Submission : Hanson Expansion Application - DA378-18 and DA462-18 2

This is a submission regarding the application by Hanson Construction Materials Pty Ltd (Hanson) for an expansion of their Red Hill Quarry. In principle we do not have an objection to the application, however we would like to see some conditions and actions taken prior to it is granted.

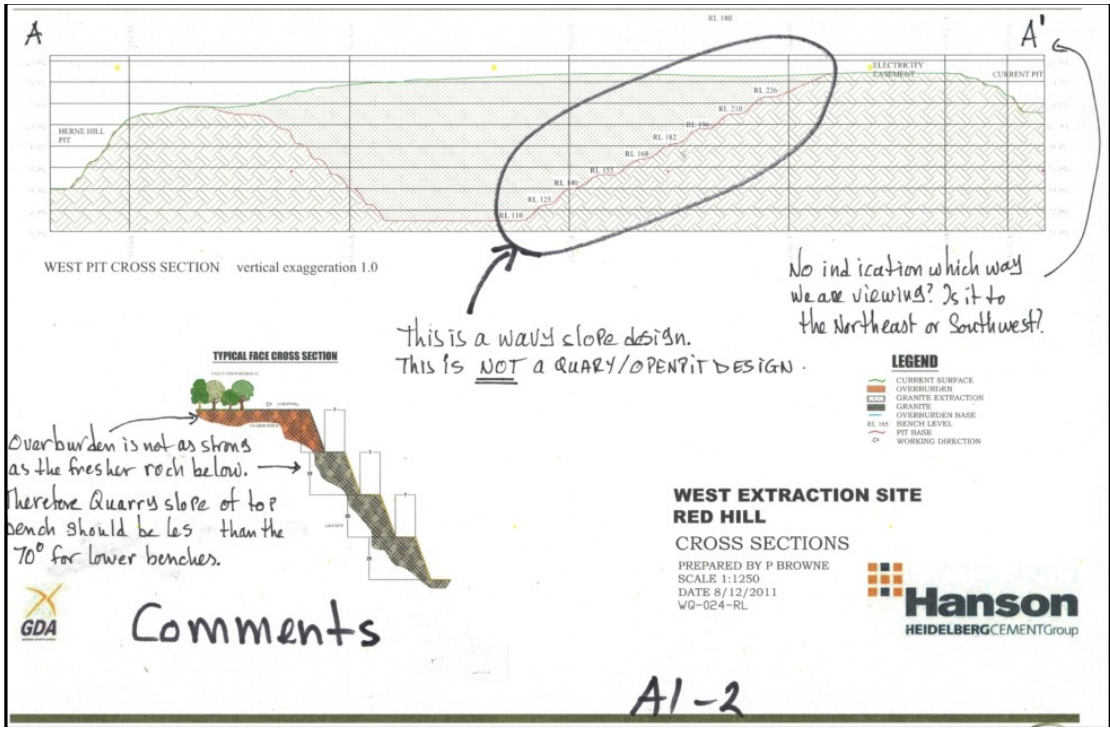
Overburden is not as strong as the fresher rock below. Therefore Quarry slope of top bench should be less than the 70° for lower benches.

Comments

This is a wavy slope design. This is NOT a QUARRY/OPENPIT DESIGN.

No indication which way we are viewing? Is it to the Northeast or Southwest?

A1-2

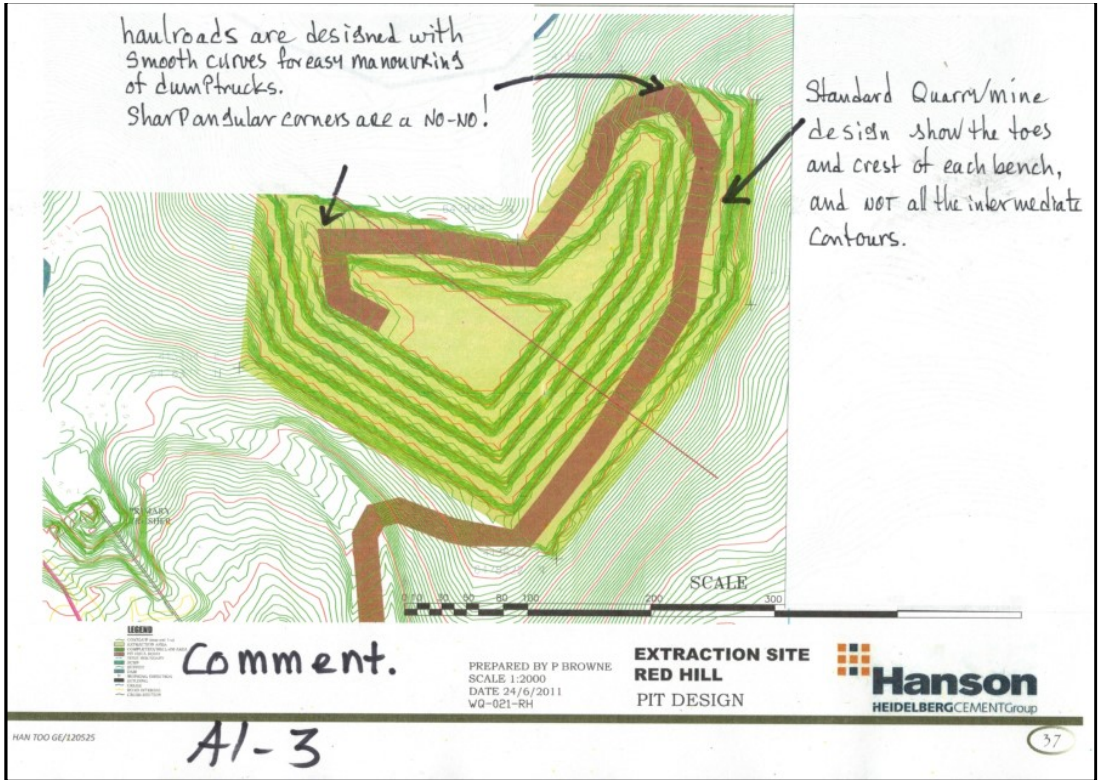
Comment.
